SAN JOSE SHELTER FOR THE HOMELESS

COST FREE CLARIFICATION

CLARIFICATION no: 4

REGARDING Foundation South wall Dining hall

F DN SECTION @ SOUTH END
OF DINING HALL (Near property line)

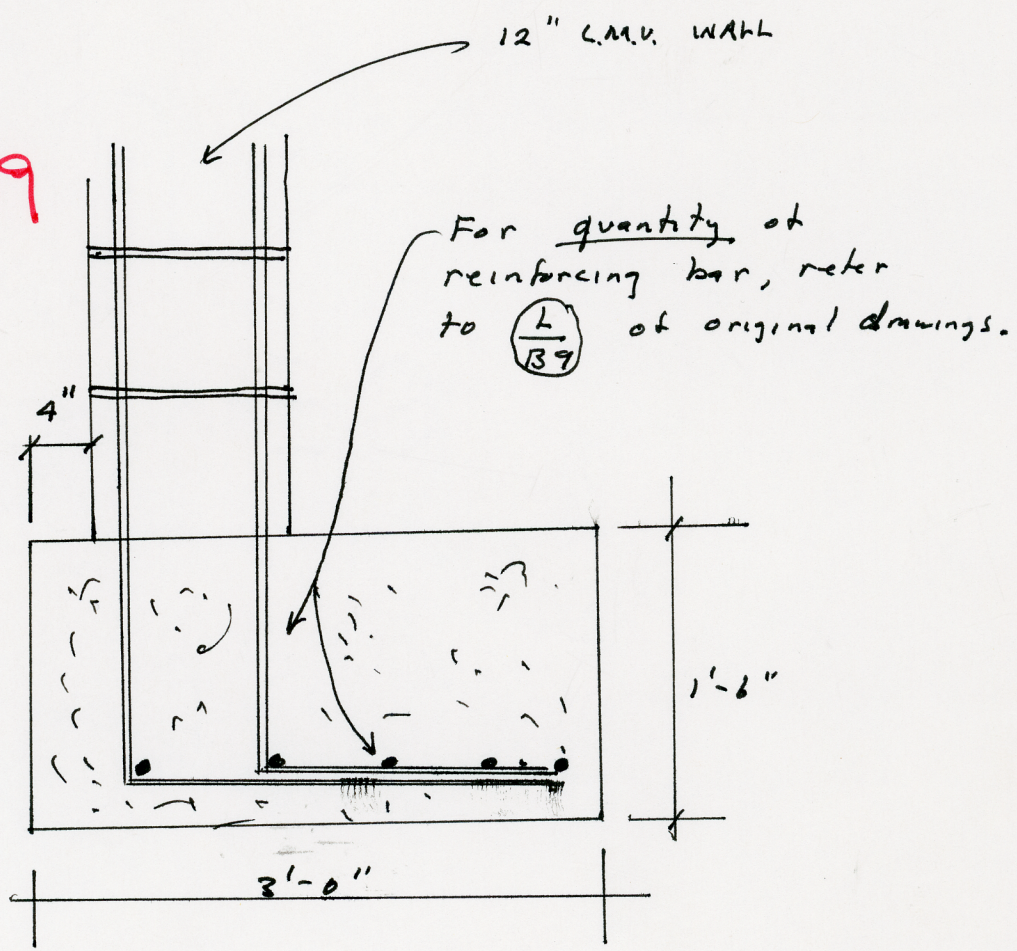
move the masonry wall relative to the concrete foundation, so that the new position places the exterior face of masonry within (4") of the outside of foundation. The old position $\frac{L}{139}$ had exterior face of masonry wall at (10") from the outside of foundation.

Reinforcing is ^{changed} ~~unchanged~~ so that all transverse steel is place in the "heel" of foundation (under the dining hall). Overall dimensions and amount of reinforcing is unchanged. Refer to $\frac{L}{139}$ of original drawings, and attached sheet
